ATR on Quality Control Check Repot. (Bungalows)

Quality Control Check Report. Stage: After Column Casting (villas)

Description	Direction	Owners & Developers :	Date :	Prepared By :	Scale :
QUALITY CONTROL GROUND FLOOR SLAB CHECK PLAN TYPE-A2	N 	Silver Oak Realty	23.10.2017	Nagalaxmi	N.T.S
		Project Name & Phase : Silver Oak Villas		Approved By : Soham Modi	
				Modi Properties & Investments Pvt. Ltd. Phone:-91-40-6633551

Description	Direction	Owners & Developers	Date	Promoted by
	M	Silver Oak Realty Project Name & Phase:	09.12.2017	Modi Properties & Investments Pvt. Ltd. Phone: +91-40-66335551
QUALITY CONTROL COLUMN POSITION CHECK PLAN TYPE: A2	Project Name & Phase:		Prepared By:	
	Soham Modi		Approved By:

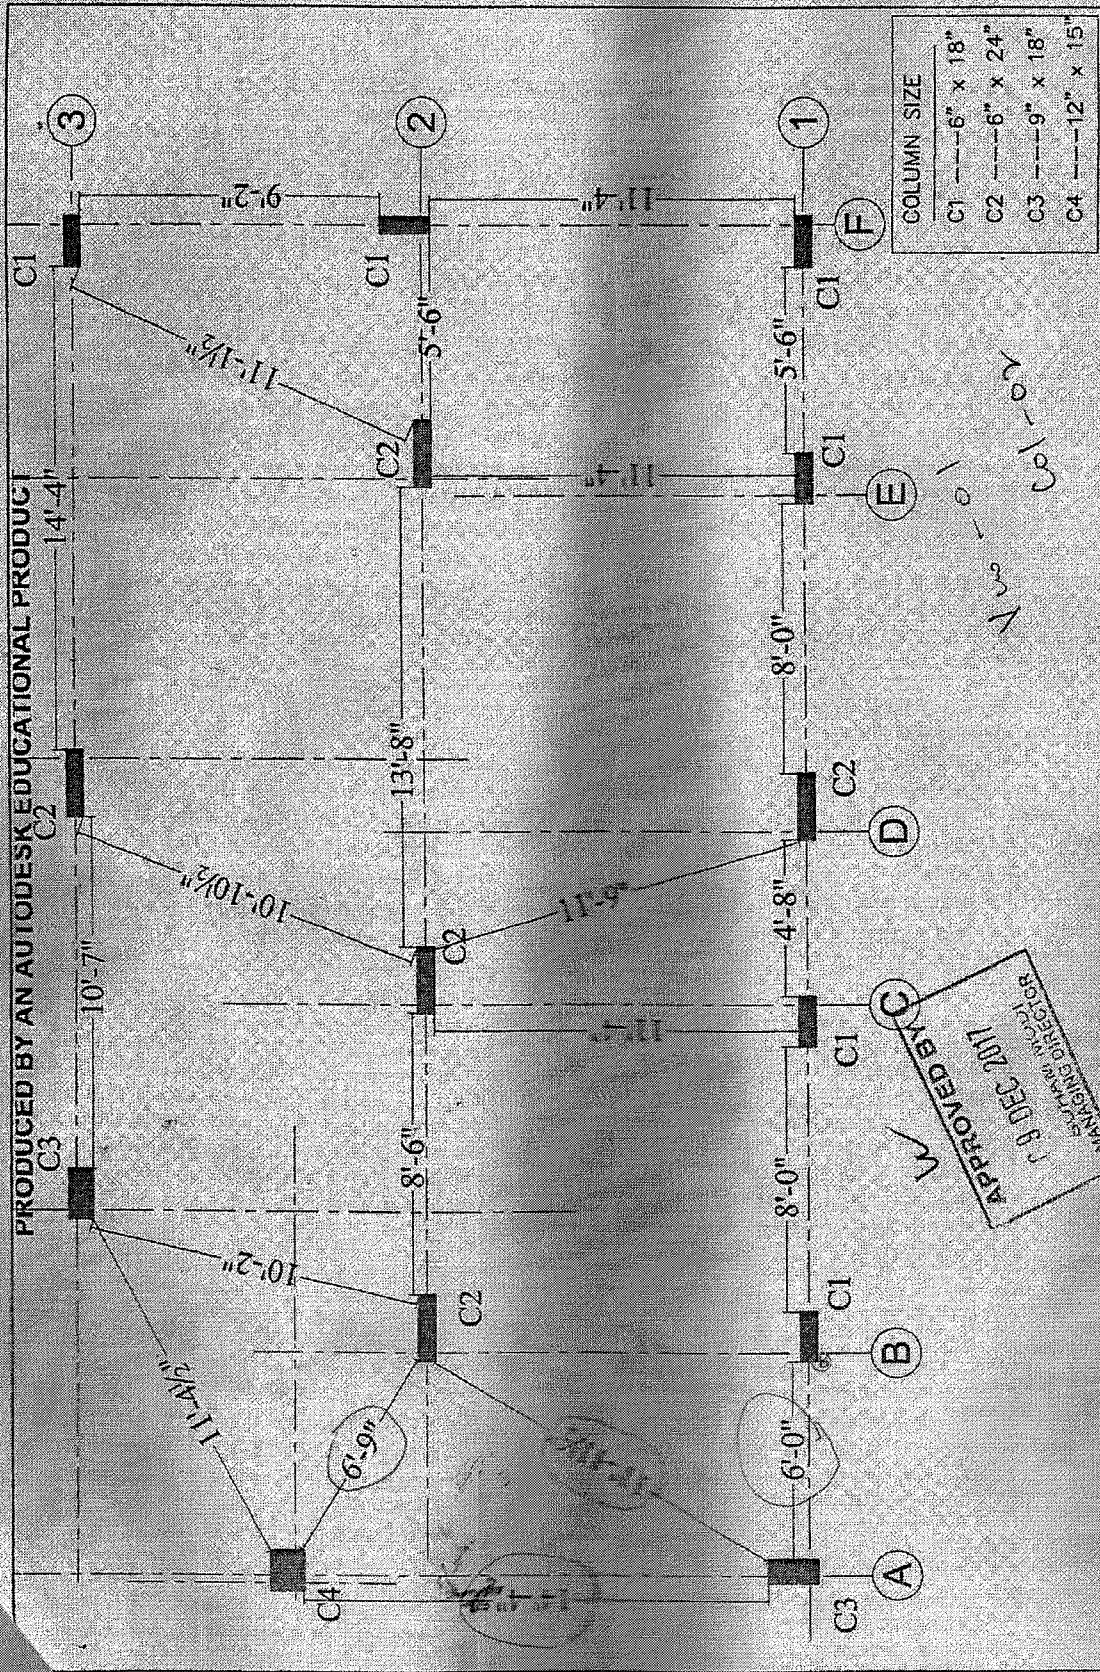
Columns Position Check.

1. Inspection should be done after casting of columns at each stage and before starting centering works for each slab.
2. Prepare Columns Position Check Plan as follows:
 - a. Divide blocks into smaller and blocks
 - b. Show size and orientation of columns. (Tolerance 0.5")
 - c. Show inner - inner space between columns. (Tolerance 1")
 - d. Show diagonals for 20% of bays. (Tolerance 1.5")
 - e. Print an A3 size plan.
3. Circle each correct dimension with green colour. Circle each incorrect dimension with red colour and mention actual dimension next to it.

Note :- Took permission from MD
 As per working drawing dimension are Ok.

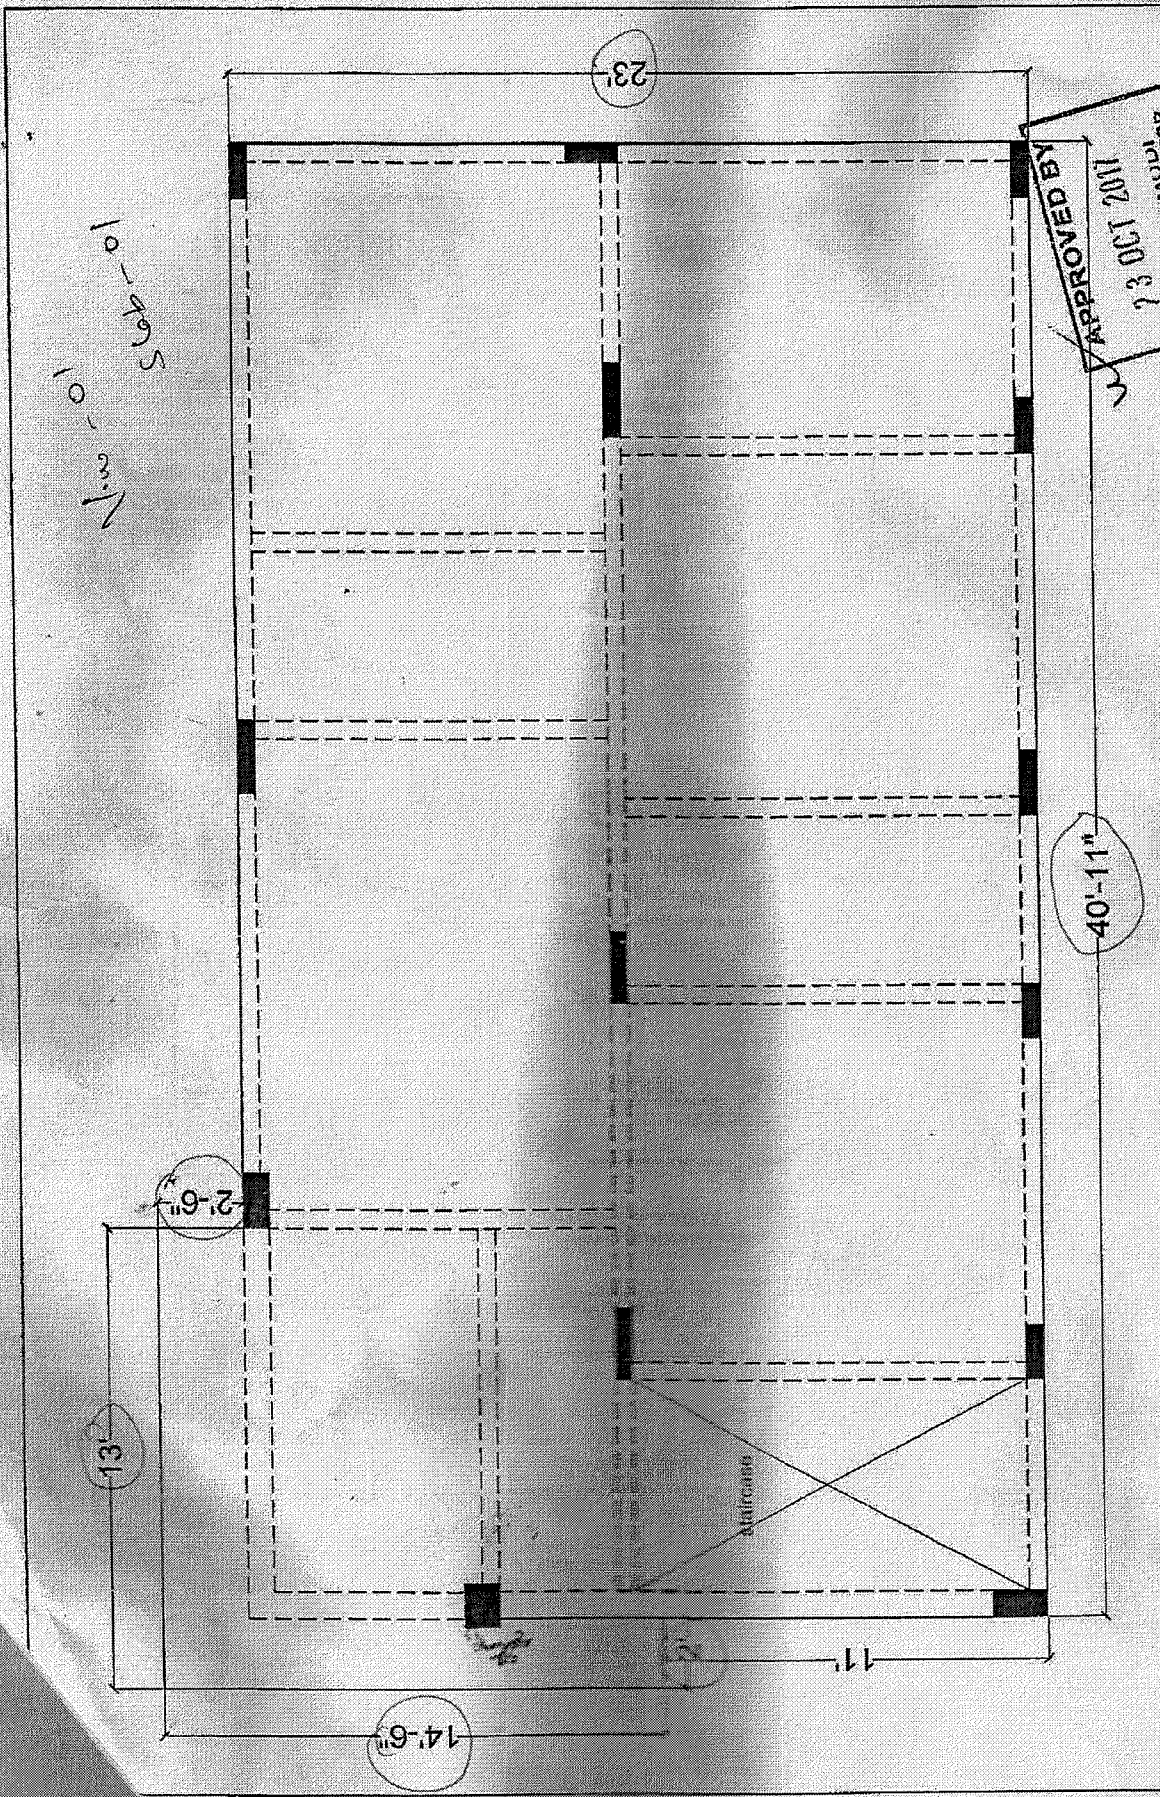
Slab Dimensions Check.

1. Prepare Slab (or plinth beams) Dimensions Check Plan as follows:
 - a. Show outer dimensions of slab. (Tolerance 2")
 - b. Show length and width of balconies (Tolerance 1")
 - c. Show inner dimensions of ducts and lift well. (Tolerance 1")
 - d. Show location of sunken slab.
 - e. Print an A3 size plan.
2. Circle each correct dimension with green colour. Circle each incorrect dimension with red colour and mention actual dimension next to it.
